Re: Solutia Inc. – W. G. Krummrich Plant, RCRA

Enclosed are the Solutia responses to the agency's May 4th, 2005 comments. Also enclosed are the following two documents:

Distribution List
May 27th, 2005 Response to Comments

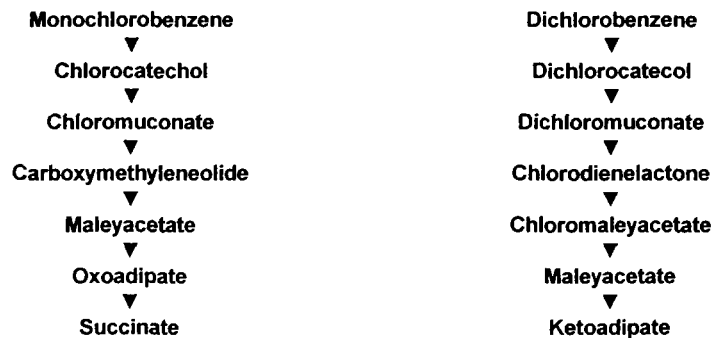
Based on the CMS data for DHU wells, other hazardous constituents such as benzene, ethylbenzene, toluene, xylenes, 2-chlorophenol, 2,4-dichlorophenol, phenol, p-chloroaniline, and naphthalene are also present in deep groundwater. It would be preferable to analyze groundwater for all RCRA hazardous constituents (e.g., RCRA Appendix IX Ground-Water Monitoring List) to see what is present and then propose an analyte list based on that data.

RESPONSE: Groundwater samples obtained during the first sampling round will be analyzed for RCRA hazardous constituents, specifically 40 CFR Appendix IX VOCs (Method 8260B), SVOCs (Method 8270C), PCBs (Method 680), Pesticides (Method 8081A), Herbicides (Method 8151A), and Metals (Method 6010). A focused analyte list will then be proposed for subsequent events.
